**Re: FedEx Ground ABQ Drainage Report and Grading Plan and Drainage Plan
Engineer's Stamp Date 10-20-14 (K09D026A)**

**RE: FedEx Ground ABQ Drainage Report and Grading Plan and Drainage Plan
Engineer's Stamp Date 9-12-14 (K09D026A)**

**FEDEX GROUND ABQ
ALBUQUERQUE, NEW MEXICO**

VINCENT P. CARRICA P.E. #16212	ENGINEER'S SEAL	FEDEX GROUND ALBUQUERQUE, NM	DRAWN BY DY
	GRADING AND DRAINAGE PLAN	TERRA WEST, LLC 5571 MIDWAY PARK PLACE NE ALBUQUERQUE, NM 87109 (505) 858-3100 www.tierrowestllc.com	DATE 10-9-14
			2013075-GRE
			SHEET # GR-3

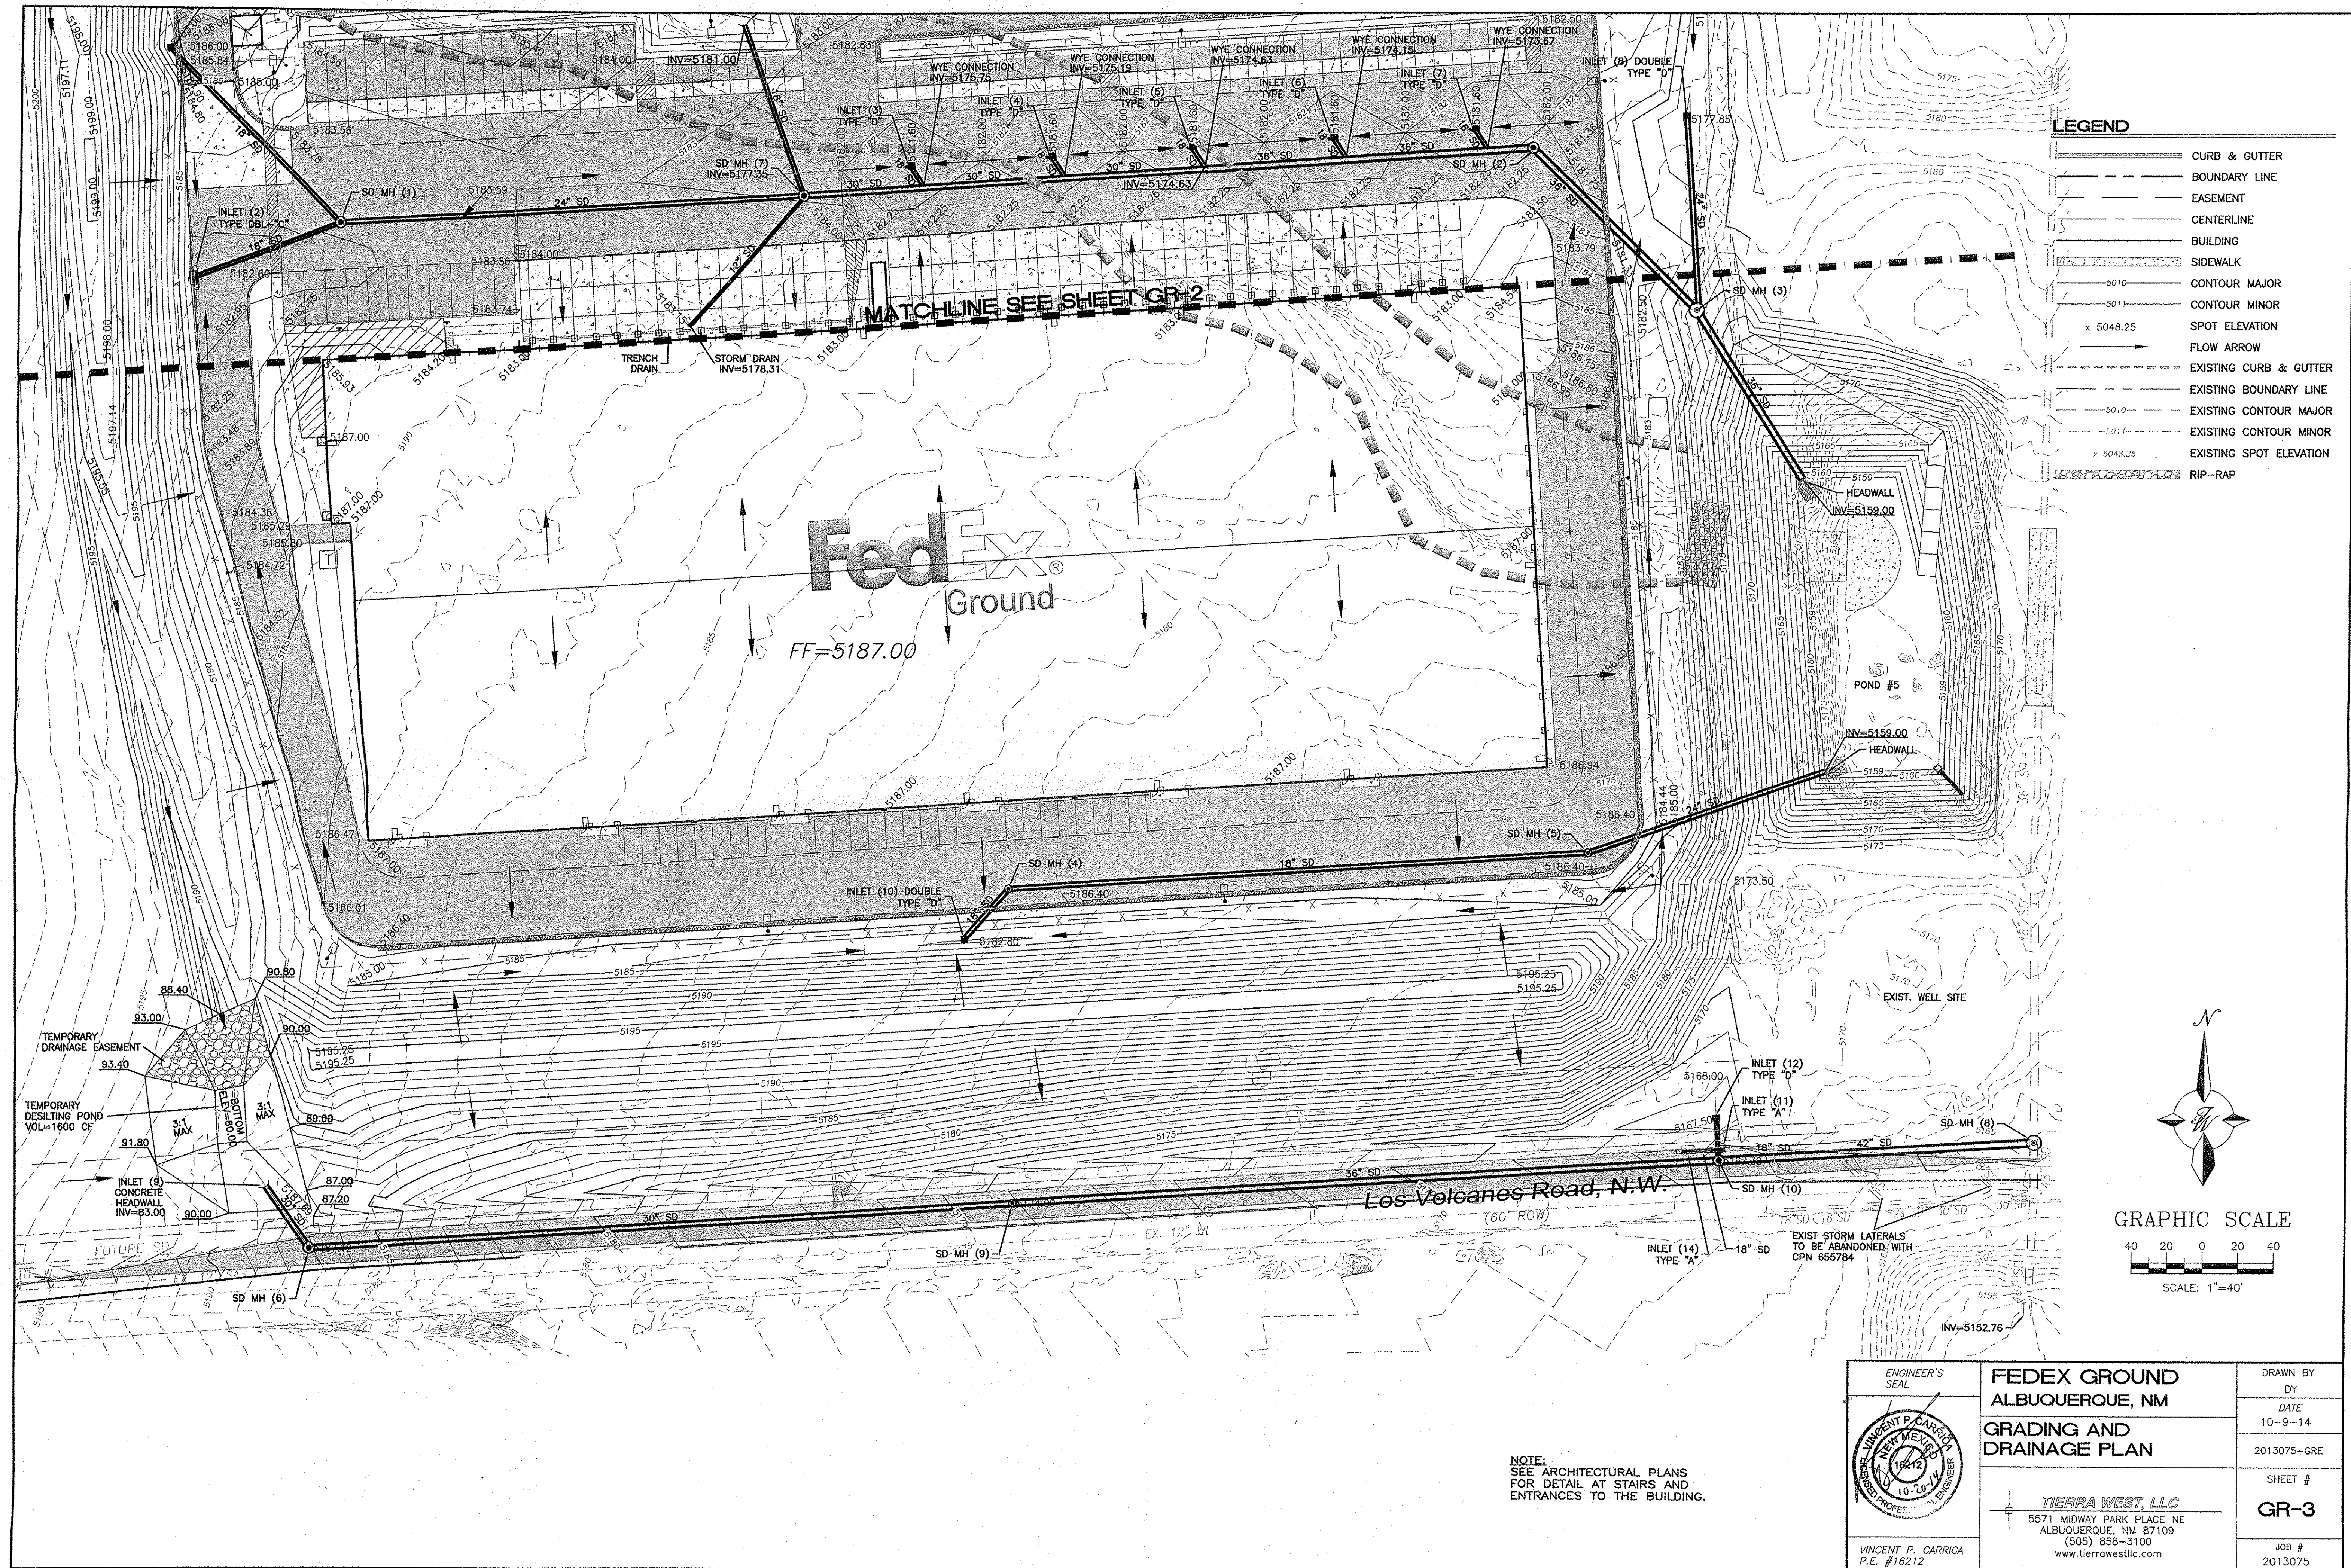
8. Where the 18 inch storm drains connect to the storm pipe north of the building, what are the inverts?

Response: Noted inverts have been added to sheet GR-3.

<p>VINCENT P. CARRICA P.E. #16212</p>	FEDEX GROUND ALBUQUERQUE, NM	DRAWN BY DY
	GRADING AND DRAINAGE DETAILS	DATE 10-9-14
	TERRA WEST, LLC 5571 MIDWAY PARK PLACE NE ALBUQUERQUE, NM 87109 (505) 858-3100 www.tierrawestllc.com	2013075-GRE
		SHEET # GR-4
		JOB # 2013075

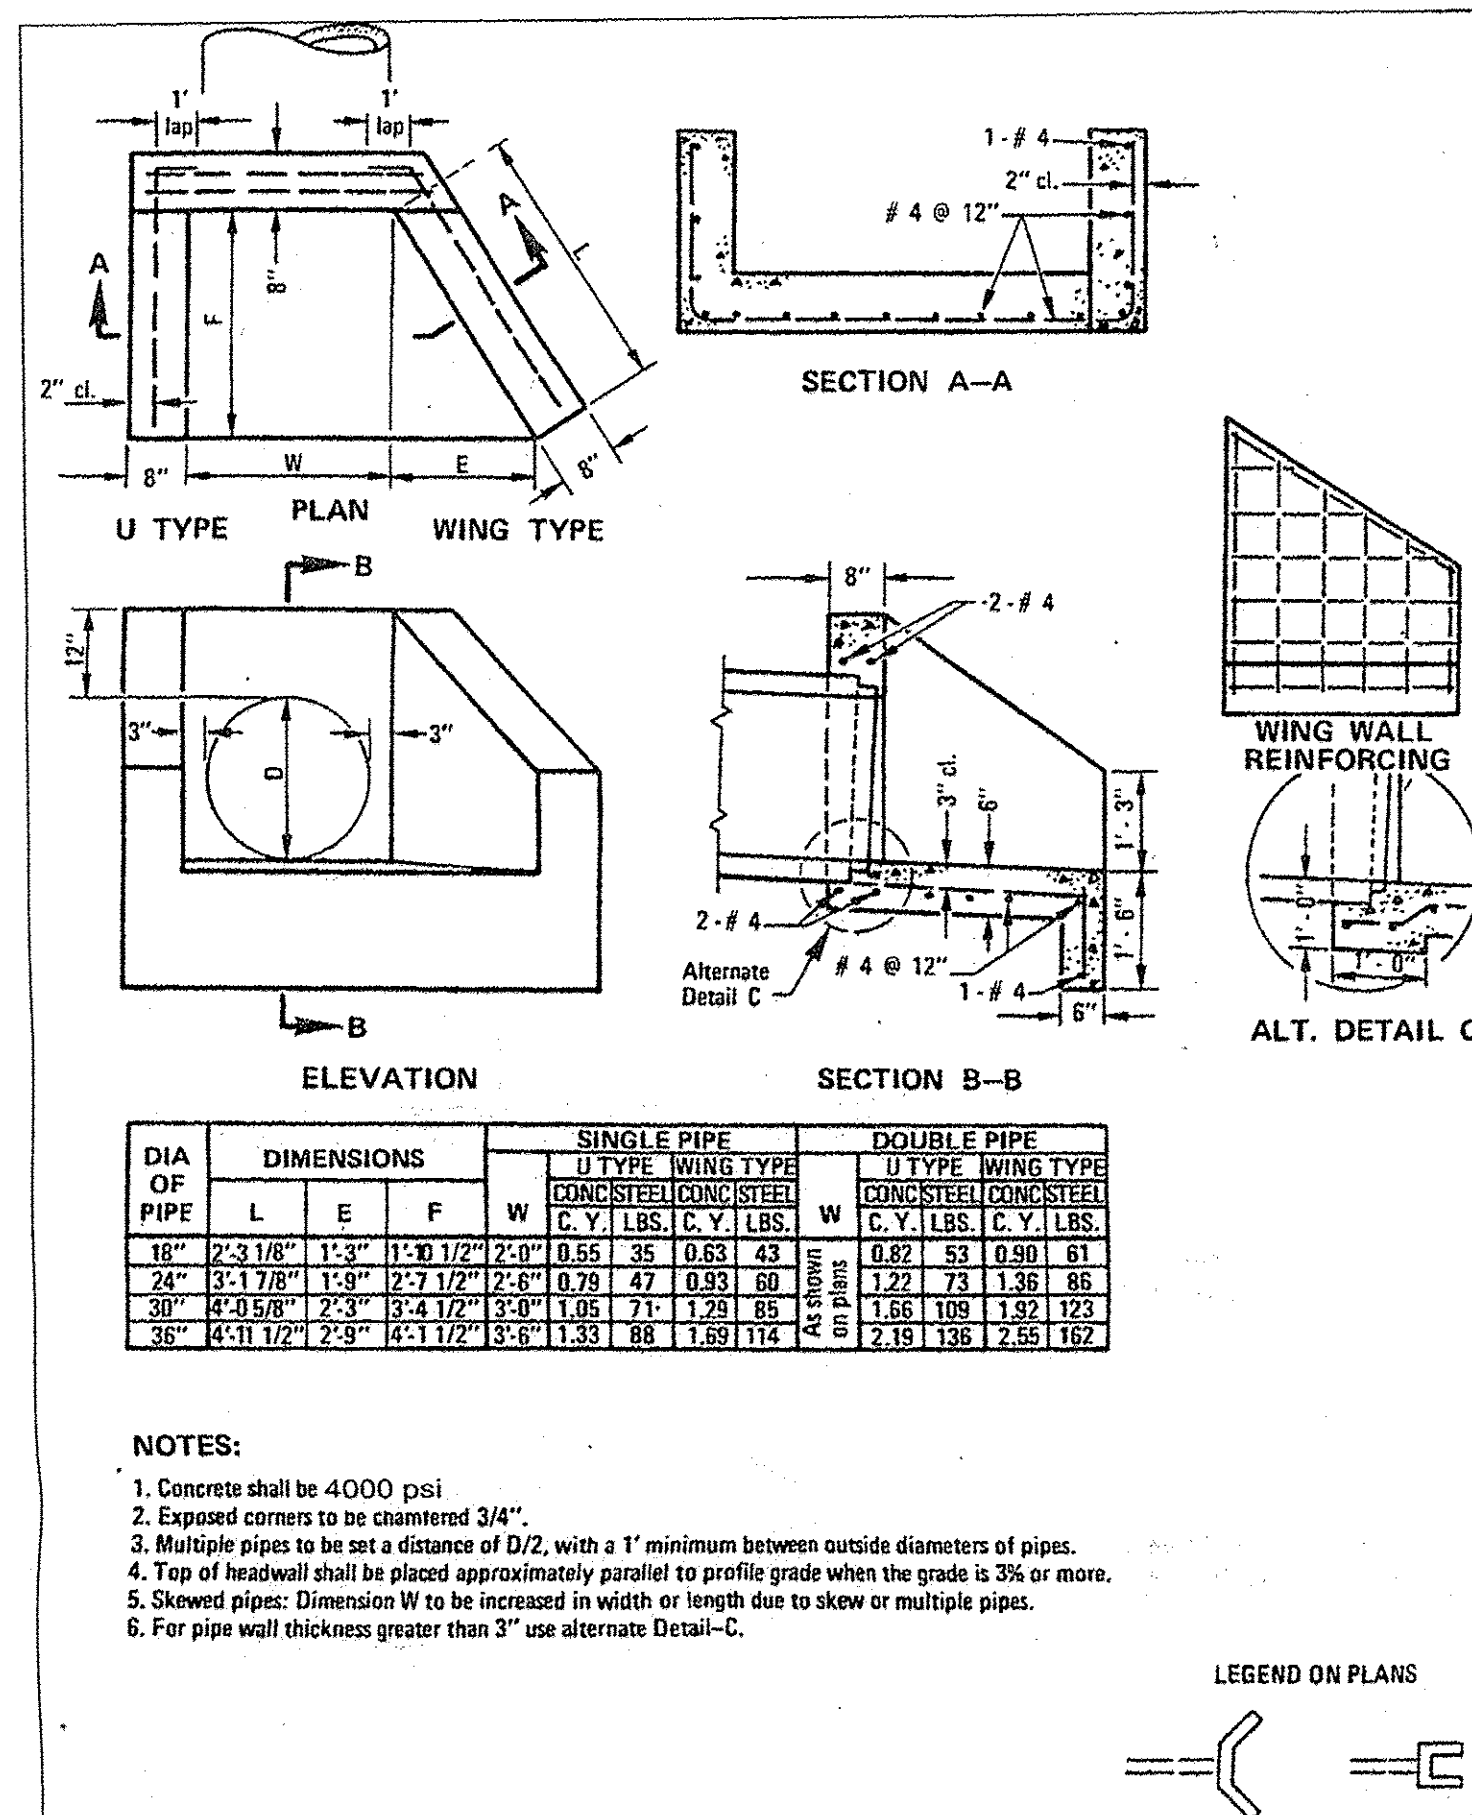
7. Provide a detail (width and size) for the rip-rap along the east and south sides of the parking lot.

Response: A detail has been added to sheet GR-4.

ENGINEER'S SEAL RONALD R. BOHANNAN P.E. #7868	FEDEX GROUND ALBUQUERQUE, NM	DRAWN BY pm
	DAYTONA RD - GRADING AND DRAINAGE IMPROVEMENTS	DATE 10-20-14
	TERRA WEST, LLC 5571 MIDWAY PARK PL NE ALBUQUERQUE, NEW MEXICO 87109 (505) 858-3100 www.tierrawestllc.com	DRAWING 2013075-DAYTONA
		SHEET # GR-5

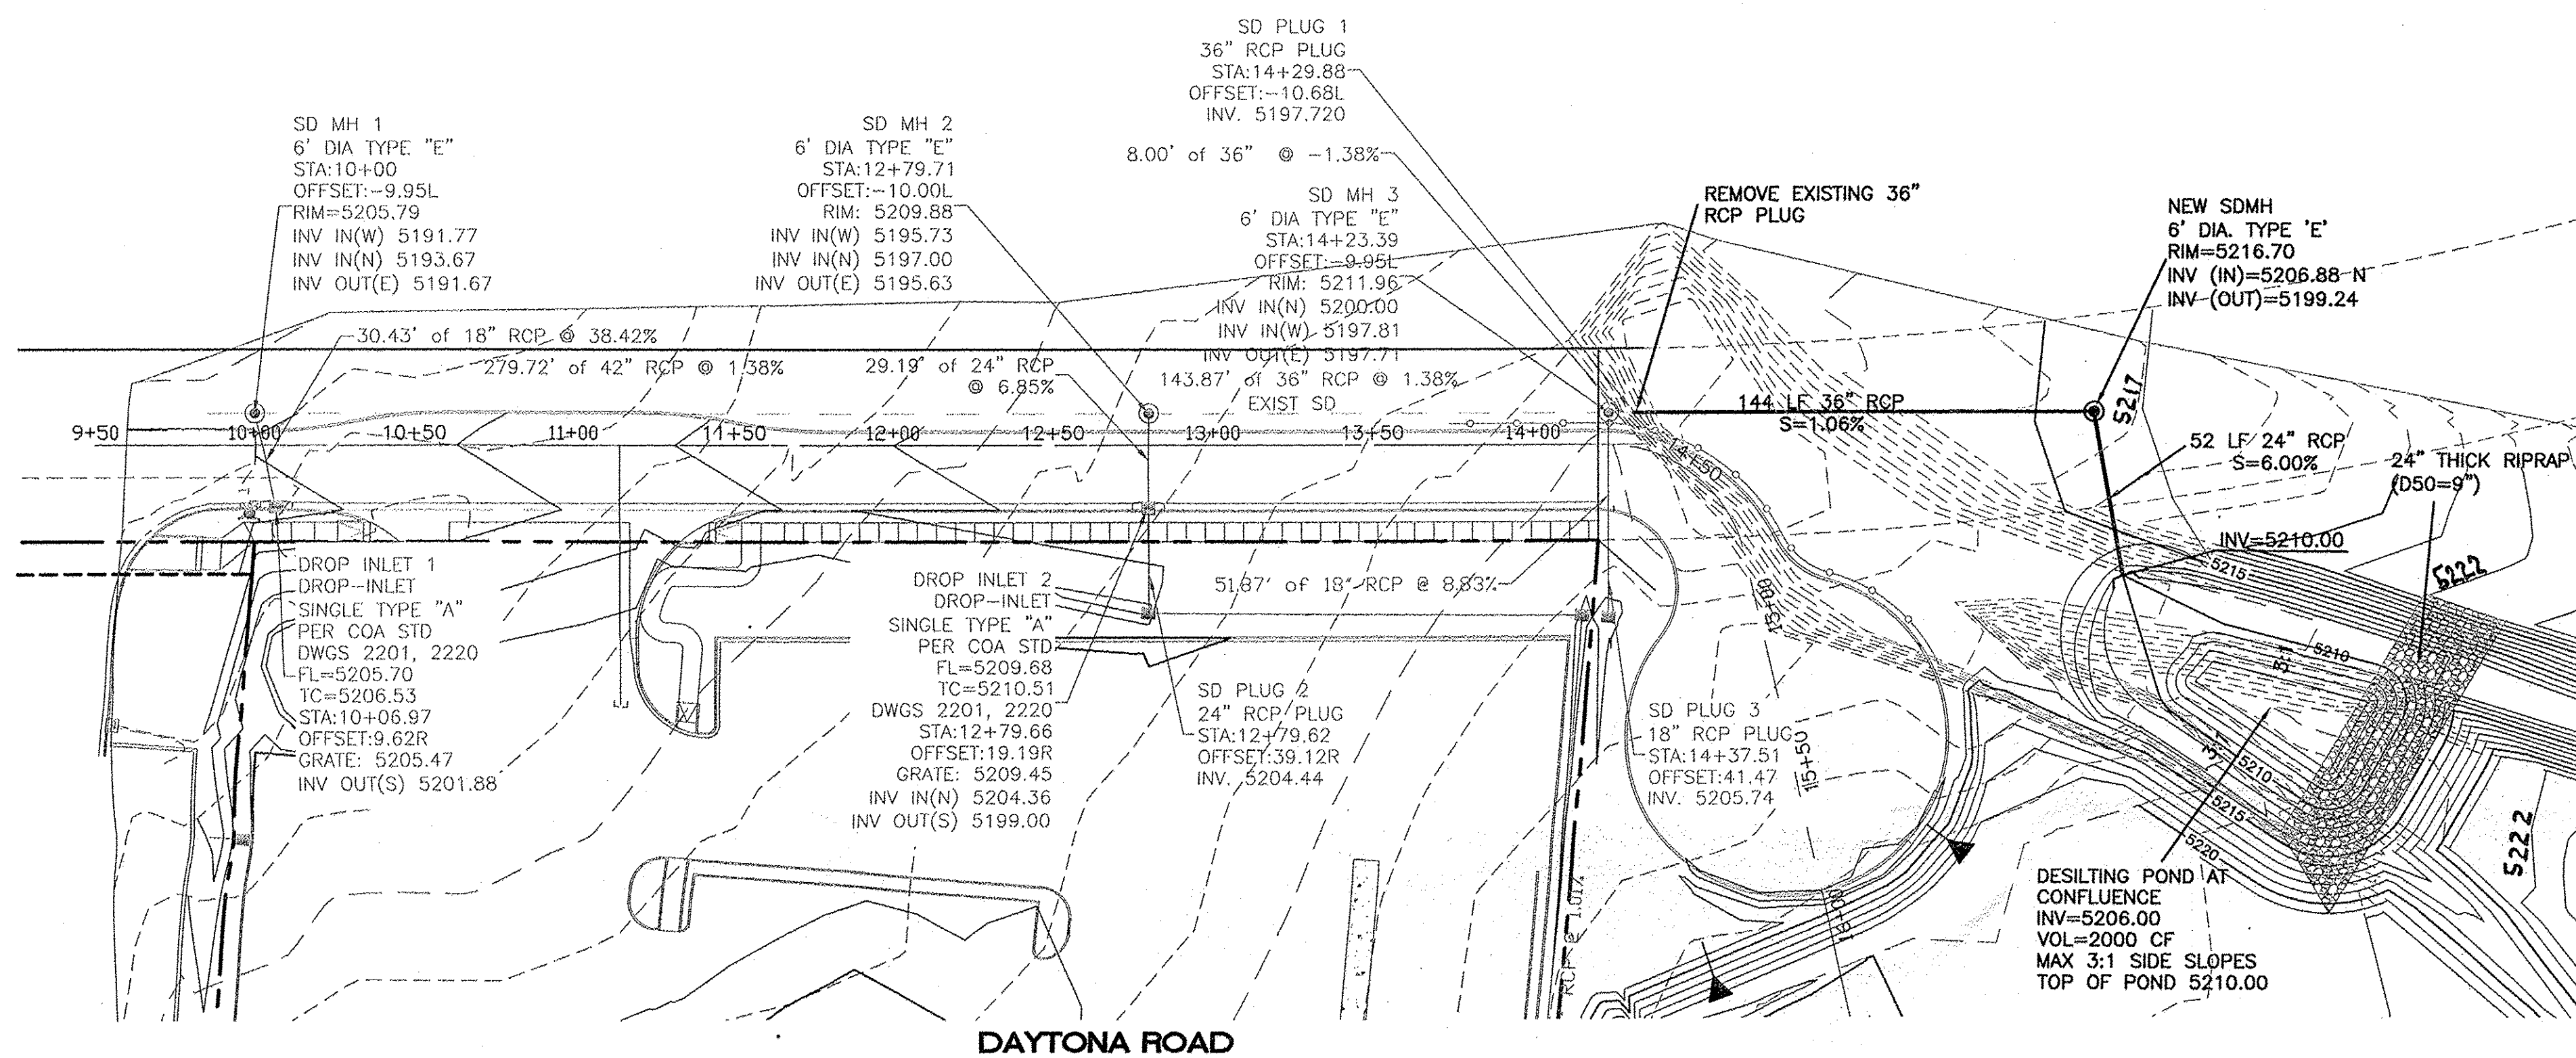
1. On sheet G-6, a desiltation pond is shown northwest of Daytona. Provide rip-rap on the upward slope from the bottom of the pond elevation to the top of pond. Include a top of pond elevation. Show existing contour elevations that the pond is tying into. What is the top of pond elevation? Provide a swale from the top of pond to the concrete pad for the 24 inch storm pipe. Ultimately, the 24 inch storm pipe will receive 48 cfs. The pipe is at a 20% slope. Reduce the slope and provide the HGL for the proposed 24 inch and 36 inch pipe n Daytona. Also provide the HGL for the storm drain in Los Volcanes. The ROW for Daytona begins to curve near the pond. Show the correct ROW.

Response: Rip rap, contour elevations, top of pond elevation and a swale have been added to the pond layout. The slope of the 24" lateral pipe has been reduced to 6%. P&P sheets from the work order set are attached for reference with HGL information for both Los Volcanes and Daytona storm drains. The right of way for Daytona is updated on the plan.
